Economic Commission for Europe**Inland Transport Committee****World Forum for Harmonization of Vehicle Regulations****Working Party on General Safety Provisions****109th session**

Regulation No. 110 (Specific components for CNG)**Proposal for the 02 series of amendments to Regulation No. 110
(Specific components for CNG)****Submitted by the expert from Japan^{*}**

The text reproduced below was prepared by the expert from Japan proposing to remove the provisions for welded constructions of compressed natural gas (CNG) cylinders or metal liners, including high-strength steel CNG cylinders. It is based on informal documents GRSG-107-09, GRSG-107-37 and GRSG-108-11, distributed during the previous sessions of the Working Party on General Safety Provisions (GRSG) (see report ECE/TRANS/WP.29/GRSG/87, para. 43). The modifications to the current text of Regulation No. 110 are marked in bold for new characters or strikethrough for deleted characters.

"Annex 2C

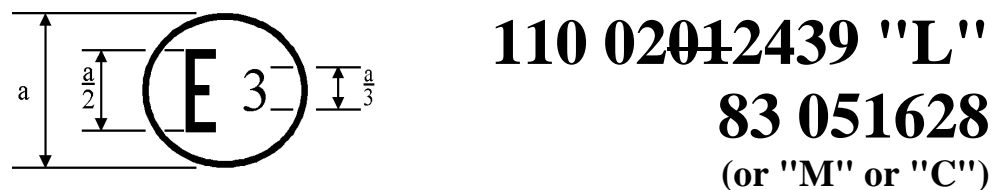
Annex 2C, amend to read:

The above approval mark affixed to a vehicle shows that the vehicle has, with regard to the installation of CNG/LNG system for the use of natural gas for propulsion, been approved in Italy (E 3), pursuant to Regulation No. 110 under approval number ~~0201~~2439. The first two digits of the approval number indicate that the approval was granted in accordance with the requirements of Regulation No. 110 as amended by the ~~0201~~ series of amendments.
